Company	Trenz Electronic GmbH
PCN Number	PCN-20250203
Title	TE0726-04 SPI Flash Change
Subject	BOM Change
Issue Date	2025-02-13

2.1 #1 Changed flash (U5) from S25FL127SABMFV10 to S25FL128LAGMFI013.

Locate Flash (U5) on top of PCB:

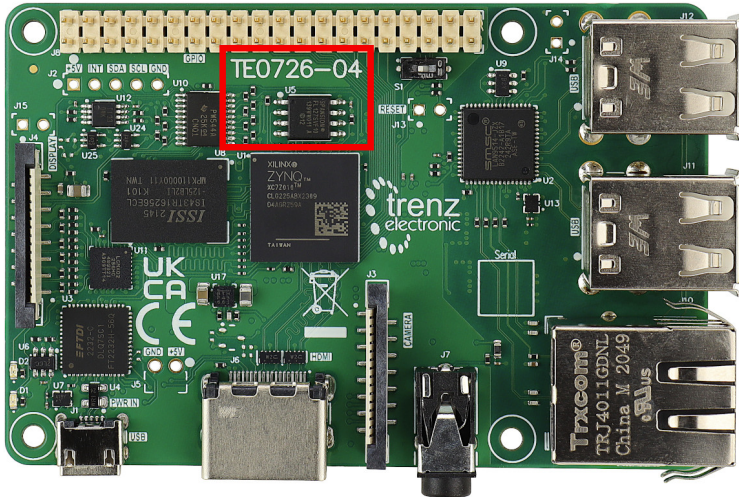
Impact: None, no changes in our 2023.2 reference design are necessary. JEDEC manufacturer is still the same. Modified device IDs and temperature grade from -40° C - 105 °C to -40 °C - 85 °C.

old	new
S25FL127SABMFV10	S25FL128LAGMFI013
